**Report Type:** DA Access Report  
**Reference Number:** 20349  
**Client:** Inglow Investments  
**Site Address:** 44-48 Rodley Avenue, Penrith, NSW

# ACCESS REPORT

This Access Compliance Report is to accompany a Development Application for the development proposed at 44-48 Rodley Avenue, Penrith, NSW.

[Image description: Plan above shows the provision of Accessible parking spaces]

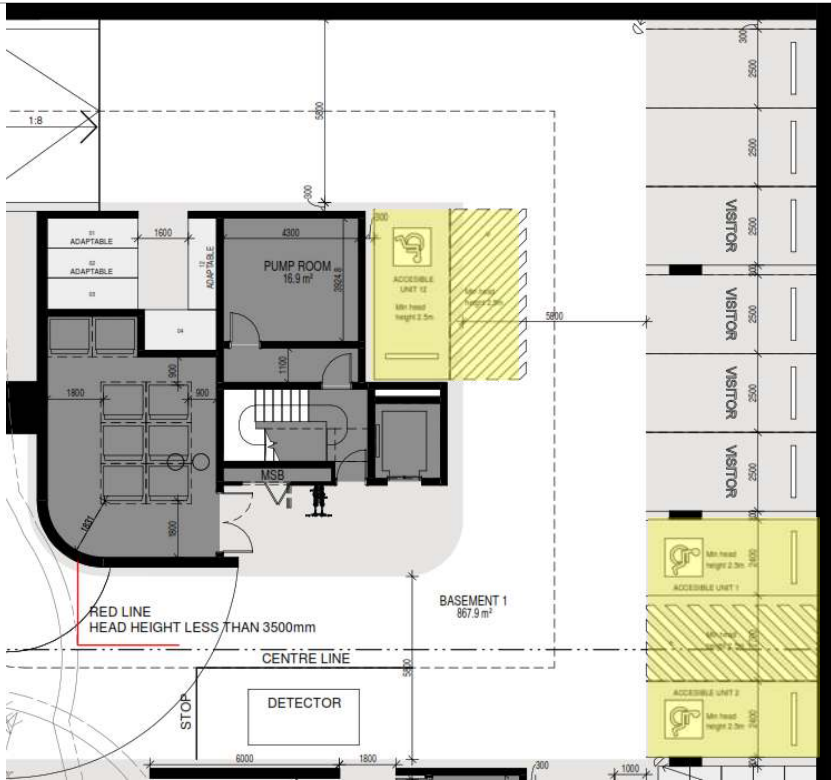
<b>Compliance Comments</b>	<p>Capable of compliance.            Details to be verified at the CC stage of works.            Refer to diagrams below for requirements, especially in regards to head height requirements.</p> <p><b>Note:</b> The pavement marking shall have the appropriate slip resistance for the location. This requirement is to be added to the project specifications to ensure compliance.</p>
	<p>5400 min length of Accessible car parking space</p> <p>1000 max</p> <p>500 max</p> <p>2500 min Clear height to dedicated &amp; shared area</p> <p>1800 min</p> <p>2200 min</p> <p>2200 min headroom</p> <p>Entry from car park</p> <p>Entire hatched area to be clear of any encroachments including but not limited to ducts, pipes, sprinkler heads, garage door panels in open position etc.</p> <p>Front of car parking space © Vista Access Architects</p>
	<p>[Image description: Diagram shows head height requirements as per AS2890.6 for both dedicated accessible parking space and the shared space. No beams, pipes, sprinklers or any other encroachments are permissible within the required clear head height space ]</p>
